RE: **41-DR-2024**
5th & Goldwater Mixed-Use
12U16 (Key Code)

Planning & Development Services has completed review of the above referenced development application resubmitted on 5/21/2025. The following comments represent issues or deficiencies identified by the review team and are intended to provide you with guidance for compliance with city codes, policies, and guidelines.

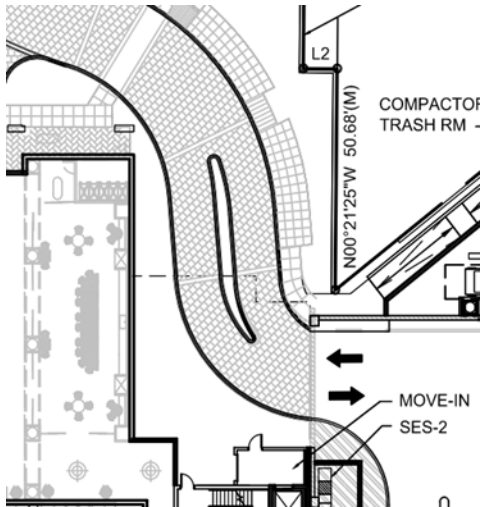
7. From 1st review, please add the allowed/provided density with calculations to the site plan. Acknowledged in the response letter but needs to be on the plan as the site plan is what the case will be stipulated to.

Defer to NPI

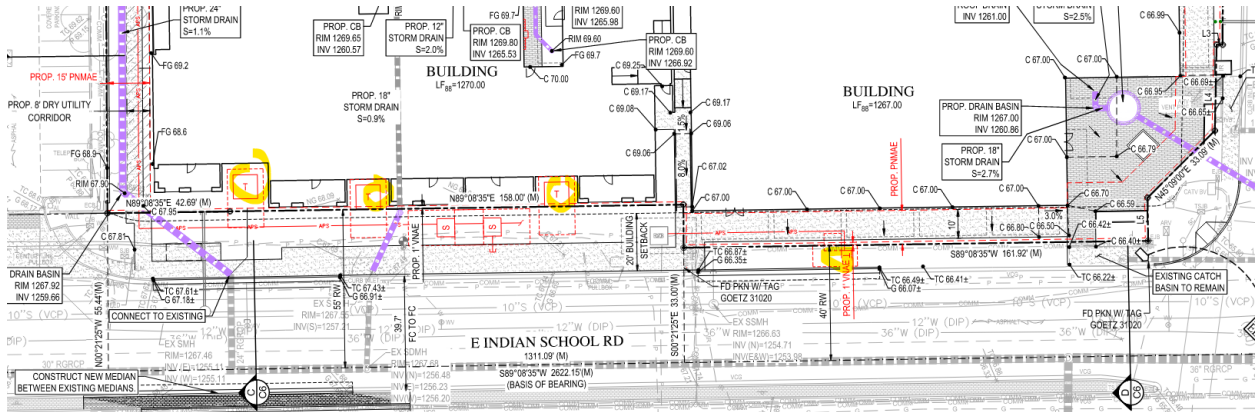
- Any soils nails or tieback construction system extending beyond the property line cannot encroach onto privately owned parcels and cannot be steel.

Defer to NPI.

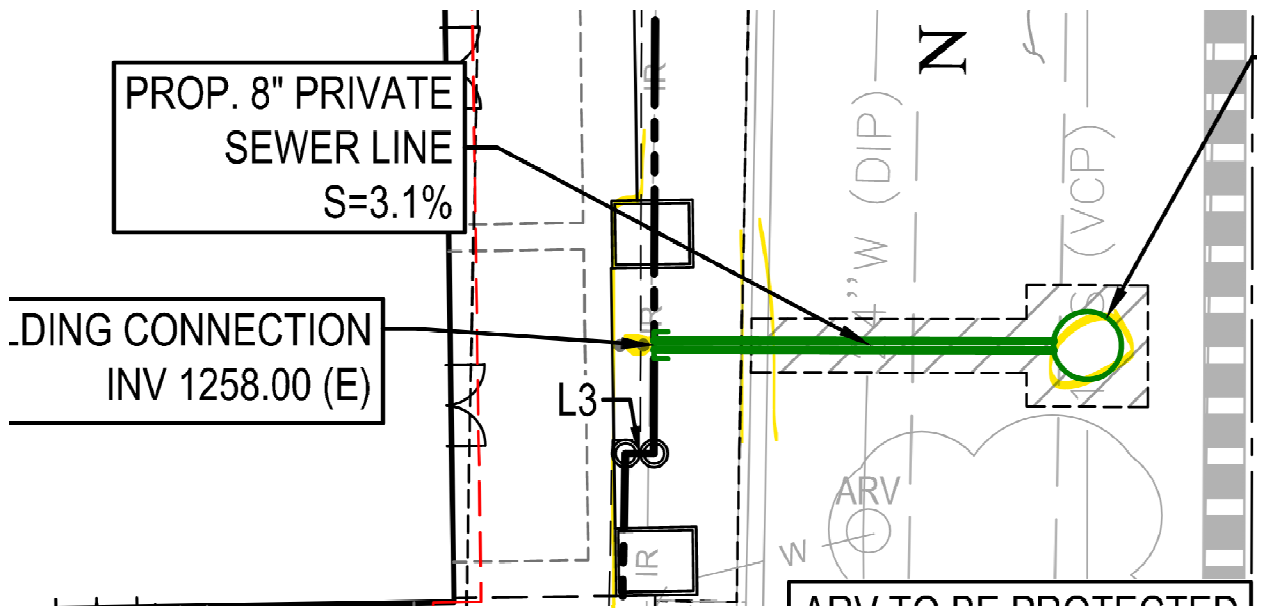
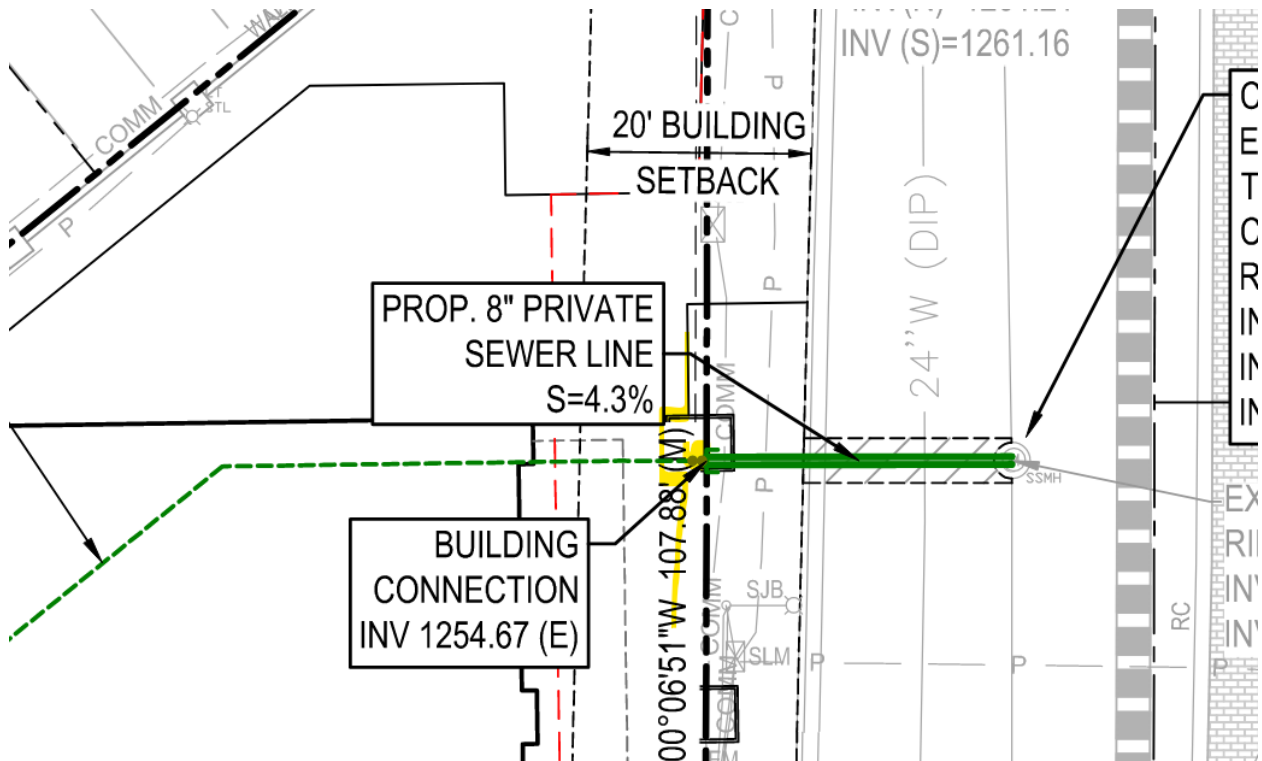
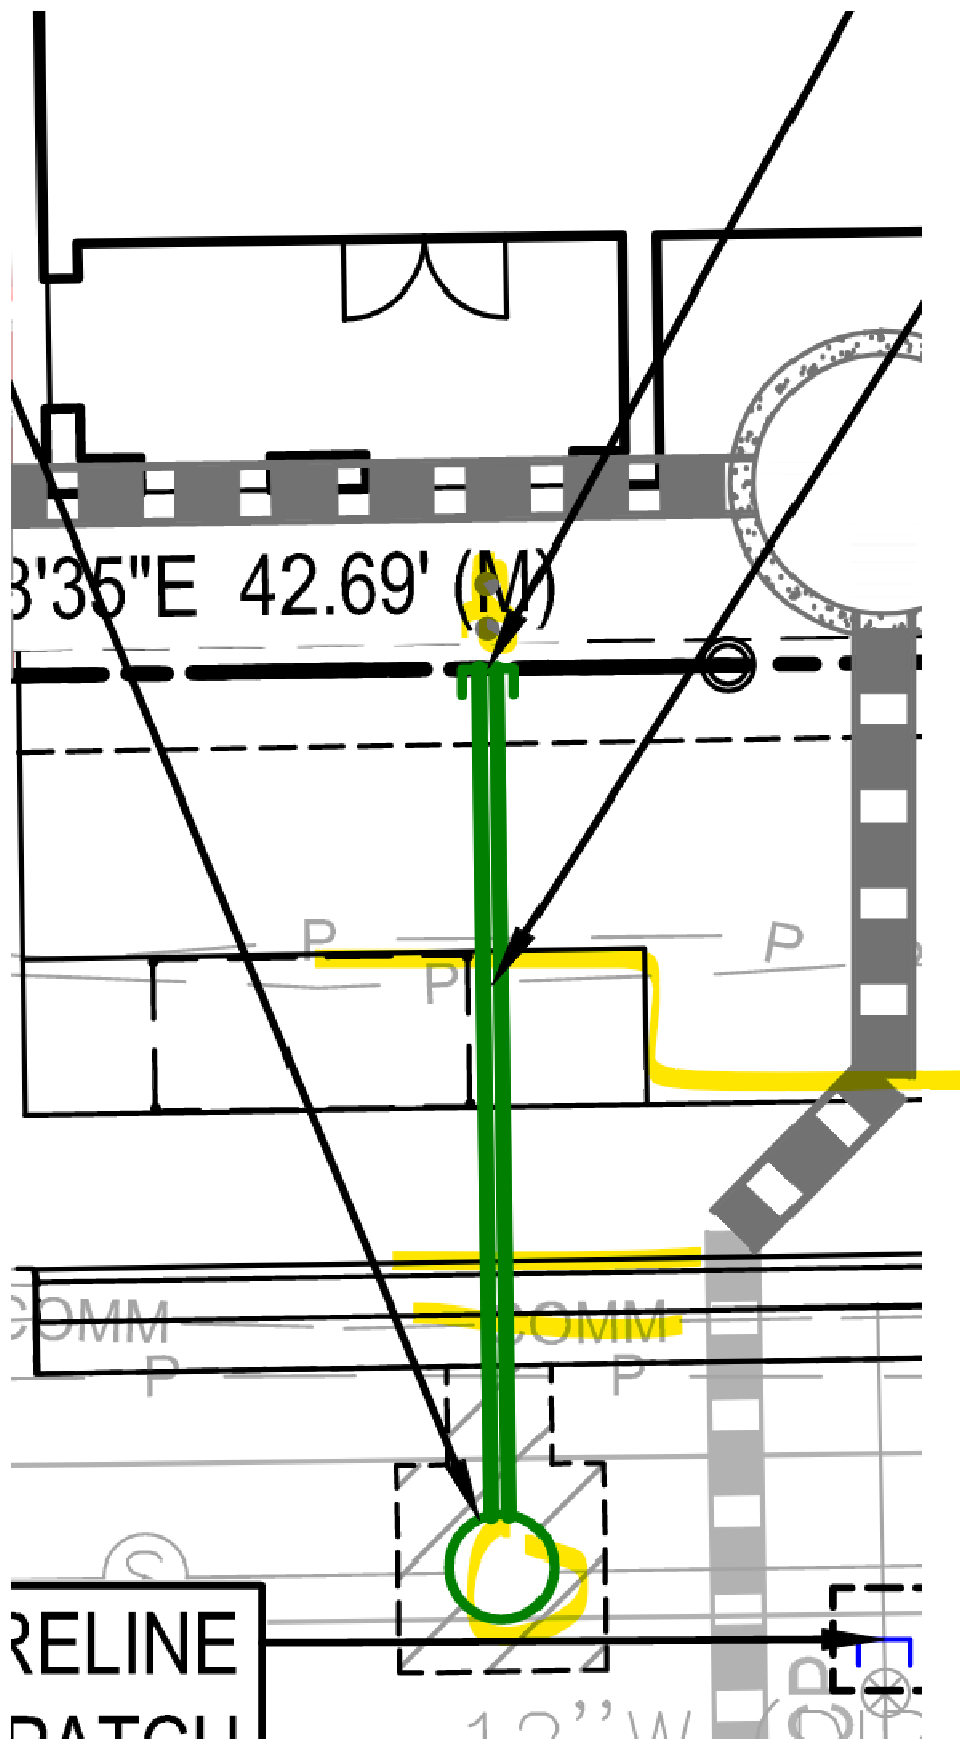
16. From 1st review, no manholes or cleanouts are permitted within city sidewalks. Note: Building sewer lines require manholes at every turn. This has not been demonstrated as the alley connection reconstruction is not shown on any of the plans. Please update utility design accordingly. Refer to Chapter 5 of the DSPM.

WOODPATEL Response: There are no cleanouts or manholes proposed in any public sidewalk. This was updated as part of the 2nd DRB submittal. For the DRB package, all the building services are straight alignments with no bends and direct connection to either existing or proposed manholes on the public mains. All manholes are in the streets, all cleanouts (double cleanouts for building connection) are in landscape areas.

The sewer relocation plan, which is a separate review being coordinated through the city review process independently, demonstrates that the manhole is outside the new driveway sidewalk.
